SDCI 3035333-LU

Design Recommendation Packet MARCH 9, 2022

210 Minor Ave N Seattle, WA 98109

210 MINOR AVENUE N • DESIGN RECOMMENDATION MEETING • SDCI 3035333-LU • MARCH 9, 2022 • 13

RESPONSE TO EARLY DESIGN GUIDANCE • MASSING

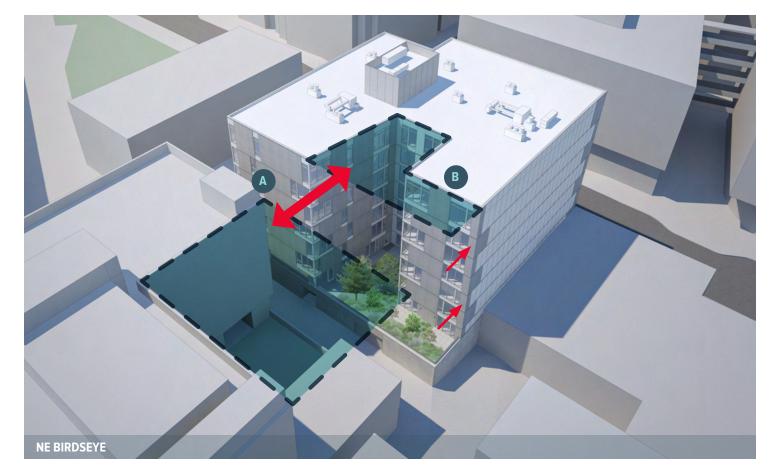
A. The Board liked how the building massing responded to the L-shaped building and courtyard orientation of the SCCA Patient House to the east of the site. The east facing courtyard of the proposed alternative successfully respected and enhanced the perceived openness between the two sites. The Board suggested that this relationship be carried forward. (CS3-A-1, PL1-A-1, & DC2-1)

B. The Board was supportive of the U-shaped plan of the preferred option and how the truncated north wing both opened the courtyard to the northeast and reduced the effect of the zero lot-line condition created along the north property line. The Board encouraged the applicant to continue exploring ways in which to lessen the perceived height, bulk, and scale, of the massing, as it will likely remain visible for some time. (CS3-A-1, PL1-A-1, & DC2-1)

RESPONSE: The design advances the architectural massing concept supported by the Board at Early Design Guidance (Alternative-3.)

RESPONSE: The truncated north wing is maintained providing 19'-10.5" from the alley property line to the upper-level massing, increasing the setback some from the supported EDG massing, further reducing the bulk, mass and scale of the north massing and party wall. In addition, the building is held 10-feet lower than the base height limit and parapets are 14-feet lower than allowed per the zoning code. It is worth noting that since the EDG meeting, the property has been sold, so it is anticipated that the school is planning to move and the site will be redeveloped in the relatively near future. (See also page 20)

RESPONSE TO EARLY DESIGN GUIDANCE • MASSING ACCENTS

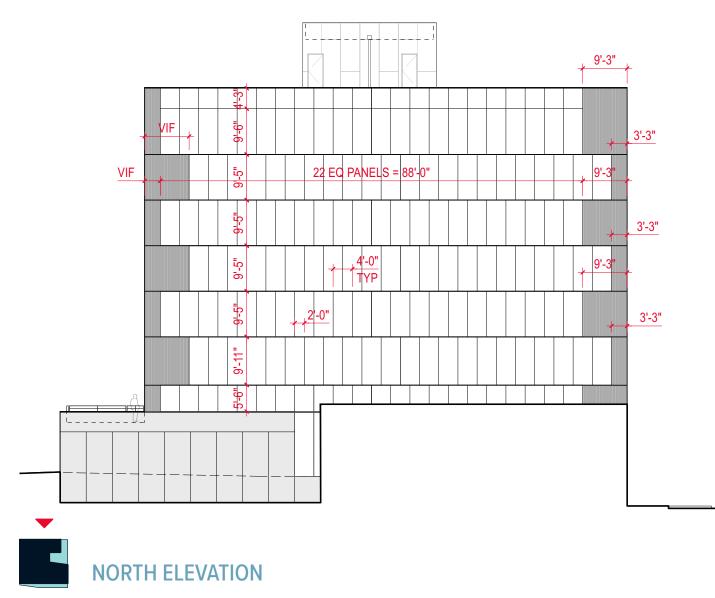
D. The Board commended the applicant's implied open and transparent treatment of the twostory setback carved out on Minor Ave N and the second floor carve out above the podium along John Street and recommended that this condition be retained moving forward. The Board suggested that the design of the storefront in this area should be different than the storefront within the podium. (PL3-A-4, PL3-1, and DC2-B-1)

E. The Board suggested that moving forward, the applicant should propose a limited, high quality, material palette that reinforces the overall massing concept as viewed from all sides and is compatible with those materials found within the immediate context. (DC2-B-1, and DC6-a)

F. The Board liked how the various soffits of the carved-out masses and the large overhanging roof at the top floor were visible from many vantage points and helped mitigate the overall perceived height, bulk, and scale. The Board gave guidance to choose a material that would highlight this condition while complimenting the overall building's material palette. (DC2-B-1, and DC6-a)

RESPONSE: The two-story carve along Minor Ave is maintained, and the windows in this space match the other residential windows above. The fenestration is buffered by landscaping including planters, guardrails that screen views to the interiors and raised semi-private patios. The lobby and the amenity space carved out of the upper floor are differentiated with a wood storefront system, highlighting these exceptional moments in the massing and respecting the Board's suggestion for differentiating these uses and moments. The storefront within the street-level podium along the corner of Minor and continuing along the length of John Street is differentiated with more gracious glazing. The fenestration will provide visibility to the lobby and amenity area within, as well as visibility of the street from inside, enhancing the corner, providing a beacon of activity and added security ("eyes on the street.") The tall storefront system accentuates the corner and recognizes that it is a more public zone of the apartment building.

RESPONSE: The proposed material palette is simple and subtle, a calming set of materials and colors that strives for wholeness and repose. The proposed material palette includes high-quality materials such as masonry at the street-level podium (in keeping with the design guidelines suggesting durable materials at the street level), wood (or wood composite) at the two-story recess along Minor where it is off the street and weatherprotected, and profiled metal panel cladding the body of the upper-level apartments. The metal panel is durable and will have an inherent textural guality, providing a sense of scale, create a play of light and demand thoughtful detailing. Painted cement panel infill panels are used as a tertiary in-fill material. The design has a natural, subtle, and simple palette with warm wood cladding and storefront systems that accentuates the carves in the massing along Minor Avenue, the corner lobby and the upper floor amenity space. This warm cladding combined with wood window and door systems at the 8th floor amenity space and main lobby accentuates those exceptional moments and reinforces the massing concept. The color tones complement each other and create an integrated wholeness to the building while providing textural differences. See also pages 38-39.

RESPONSE : The strong roof overhang is maintained and thoughtfully designed to erode the upper massing and provide some rain protection and solar shading for the upper amenity space. Wood siding and storefront are used to highlight the vertical face of the carves in the massing. The white soffits integrate with the color and material palette of the upper mass that is being carved and continue the ceilings form inside to out.

RESPONSE TO EARLY DESIGN GUIDANCE • NORTH ELEVATIONS STRATEGIES

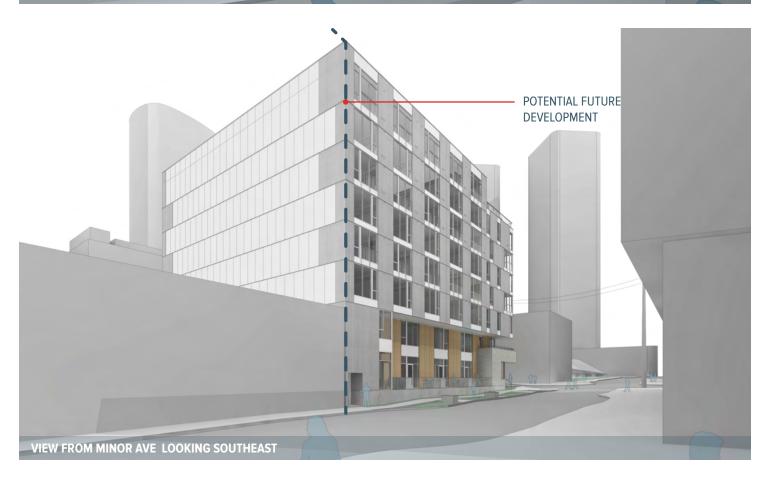
G. The Board expressed some concern that the north façade would remain exposed for some time, until the adjacent property is redeveloped. The Board gave guidance that the north façade should be designed to reflect the overall architectural concept and that high-quality materials should be applied to help mitigate the blank wall created by the zero lot-line condition proposed. (DC2-B-2)

RESPONSE: To reduce bulk and scale, the north façade wall area has been reduced in size since EDG. While the wall is required to be a fire-rated, party-wall with no fenestration allowed, the facade is animated by the use the staggered patterning concept utilized throughout the building facades and continuing the primary horizontal datums that wrap the other facades. The street-facing façade materials are wrapped around the corner of the building to create a transition and to integrate the north wall. At these corner transitions, the metal cladding alternates each floor providing a shifting effect present at the other corner conditions throughout the building. This provides some visual interest and high-quality materials to the party-wall condition.

RESPONSE TO EARLY DESIGN GUIDANCE • JOHN STREET LANDSCAPE

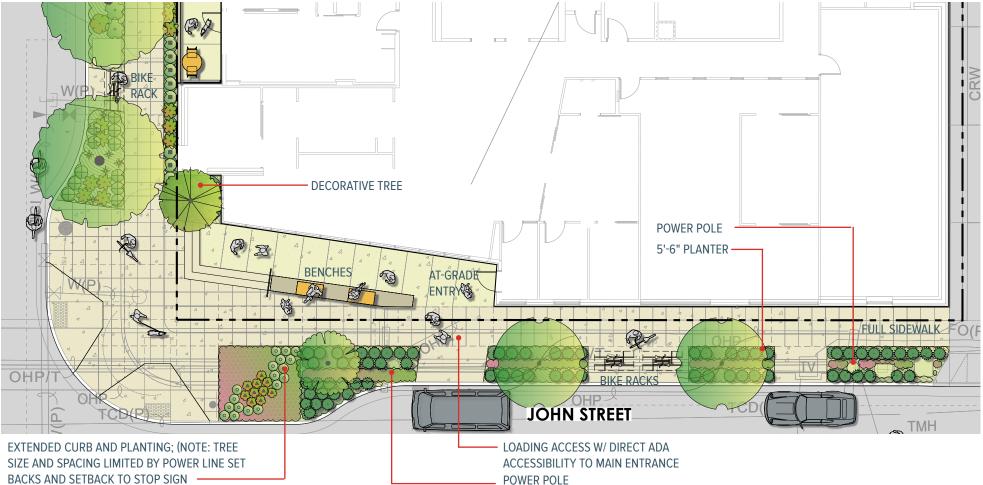
A. The Board appreciated the inclusion of the landscape buffer between the sidewalk and the raised private residential terraces along Minor Ave N, but expressed concern with the lack of landscaping along John St, a Neighborhood Green Street. The Board reiterated the importance of an integrated architectural and landscape design that compliments the adjacent program space while also enhancing the overall pedestrian experience. The Board suggested continued refinement of the landscape design to include the right-of-way and potential landscape buffers along John St. (CS2-3-f, CS2-4-a)

RESPONSE: The landscape design has evolved and been particularly influenced by the team's community outreach and engagment with the neighbors, including SCCA and Mirabella. The feedback from these meetings and the Design Review Board lead to streetscape design that includes additional landscaping along John Street, maximizing the landscape buffers to the extent allowed by SDOT, and additional site seating. In addition, the team was able to secure the protection of SCCA's planting strip in the alley that was to be paved as part of the alley widening at their request. An extended curb bulb has been added to the corner of John Street, providing additional area for plantings. The project has also voluntarily provided for a 2-foot setback along John Street to provide a standard 6-foot sidewalk and 5-foot, 6-inch planting strip including street trees. This is a wider pedestrian experience than immediately across the alley at SCCA Patient House. In addition, the design provides an extended curb bulb at the SW corner, narrowing the sidewalk while also providing a much deeper planting strip that is almost 12 feet deep. The number and spacing of the trees is limited by SDOT setback for powerline/poles and to the stop sign at the intersection. The planting strip that separates the sidewalk from the residential patios along Minor turns the corner at the lobby creating a planting area with a decorative tree between the work-fromhome amentiy space and the porch at the corner lobby window. See also page 25 and landscape design on pages 31-33.

RESPONSE TO EARLY DESIGN GUIDANCE • ENTRY PLAZA

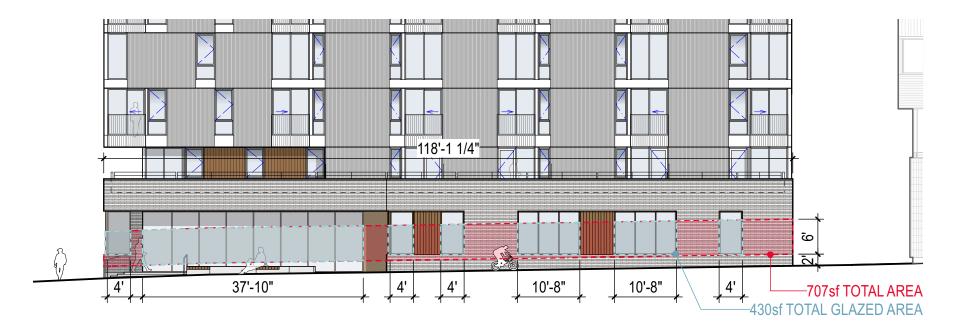
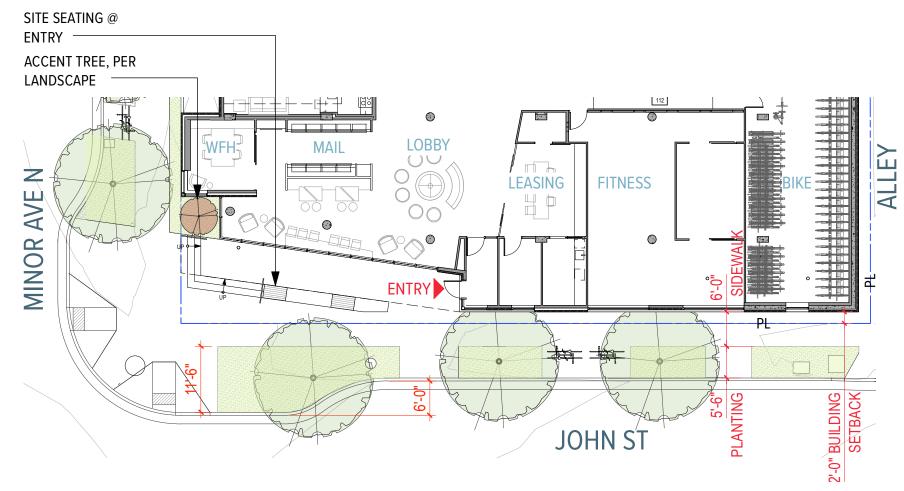
B. In conjunction with item 3.a above, the Board suggested that the applicant look at ways to increase potential interaction between the uses at the ground floor and the pedestrian realm along John St. The Board specifically gave guidance for the applicant to study carving out the amenity space to provide a terrace of similar depth with landscape buffer as the one provided at the residential units along Minor Ave N. (CS2-1-3-f, PL1-A, PL1-B, PL2-2-a, PL3 -B-2, DC1-A-1, and DC3-A-1)

RESPONSE: The design provides an enhanced, exterior, pedestrian plaza at the corner of John Street and Minor that provides visual interaction with the lobby and amenity spaces and a welcoming entry. The widened pedestrian realm seeks to gracefully mitigate the grade change of the sloping corner while providing areas for seating, builtin benches, landscaping and a semi-public porch space fronting the expanded sidewalk. The carve-out of the massing at the more public amenities of the corner program is buffered from the semi-private patios along Minor by the masonry work-from-home amenity space, while also leading visitors and occupants to the covered entry along John Street. Additional carves out of the single-story podium along John would erode the mass too much, taking away from the street wall along John Street – a continuation of the SCCA Patient House street wall – and reduce the significance of the main lobby carve at the corner.

The generous porch and corner storefront accent the lobby and entry drawing the eye to the public facing uses along the SW corner of John. Integrated site seating at the entry stairs provides an area for rest while the expanded planting strip and curb bulb protect the corner as well as provide addition greenery. A carve out of the stairs provides a pocket for an accent tree drawing the eye to the corner glass on the lobby.

RESPONSE TO EARLY DESIGN GUIDANCE • ENTRY SEQUENCE

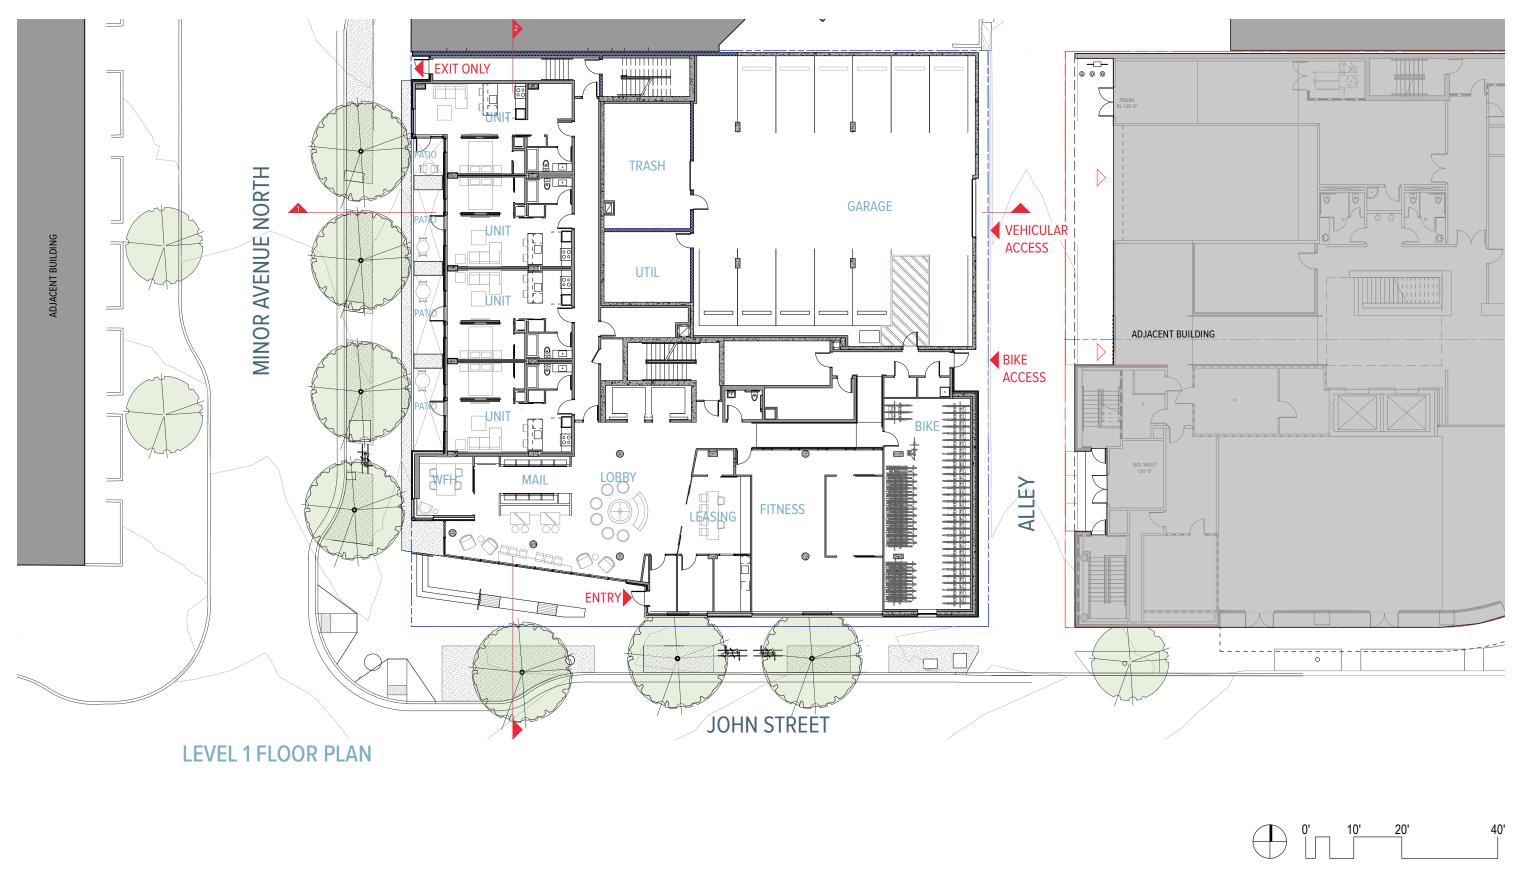
- C. The Board supported the raised entry and gracious setback at the corner of Minor Ave N and John St as it provided opportunities the corner. The Board had concerns with the accessibility of the raised terrace and gave guidance that the entry sequence with disabilities can easily access all points

located at the eastern portion of the lobby where it has direct, logical and easy ADA space at the lobby. The secondary entrance off the alley and near the bike room is also ADA accessible. The entry sequence has been revised to provide more direct access to the entry and making accessibility the

larger area for at-grade access, simplifying the corner, and accentuates the storefront
